Work Order ID 132042

Item Name: Replacement Skidtube (Fits LH or RH)

DRAWING NO. D2650	TITLE 206/407 SKIDTUBE ASSEMBLIES	REV. F	DART AEROSPACE LTD ENGINEERING ORDER		D.E.O. NO. D2650-F-1	SHEET NO. SHEET 1 OF 1	SCALE NTS
DRAWN <i>[Signature]</i>	CHECKED A.P.	MFG. APPR. <i>[Signature]</i>	APPROVED <i>[Signature]</i>		DE APPR. <i>[Signature]</i>		
DATE 12.10.12	DATE 12.10.22	DATE 12.10.22	DATE 12.10.22		DATE 12.10.22

CHANGE C'BORED WELDED CROSSBOLT SPACERS TO SWAGED SPACERS

AMENDMENT TO DETAIL B
NOT TO SCALE

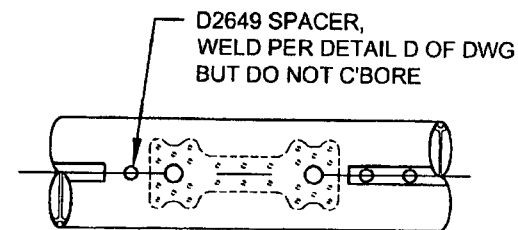
ADD DETAIL G BELOW, WHICH IS THE SAME SECTION VIEW AS DETAIL D OF DWG.
C'BORED HOLES ARE **NOW SWAGED** PER DETAIL G BELOW. FOR THE Ø0.375 HOLE THAT IS NOT C'BORED, WELD PER DETAIL D OF DWG (SEE AMENDED DETAIL B FOR REFERENCE).

DETAIL G

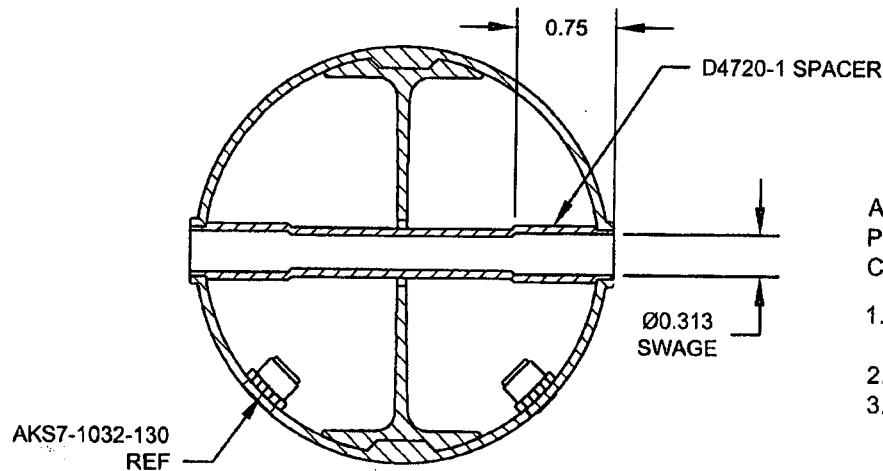
FOR Ø0.375 HOLES ONLY
FOR HOLES THAT ARE CURRENTLY C'BORED ONLY
NOT TO SCALE

AFTER DRILLING AND BENDING ASSEMBLY
PERFORM THE FOLLOWING FOR Ø0.375 HOLES THAT ARE
CURRENTLY C'BORED:

1. INSERT D4720-1 SPACER, 16 PL (-1) OR 17 PL (-3)
OR 19 PL (-5) OR 23 PL (-7)
2. SWAGE TO Ø0.313 X 0.75 DP PER QSI 002
3. TRIM / GRIND FLUSH PER QSI 002
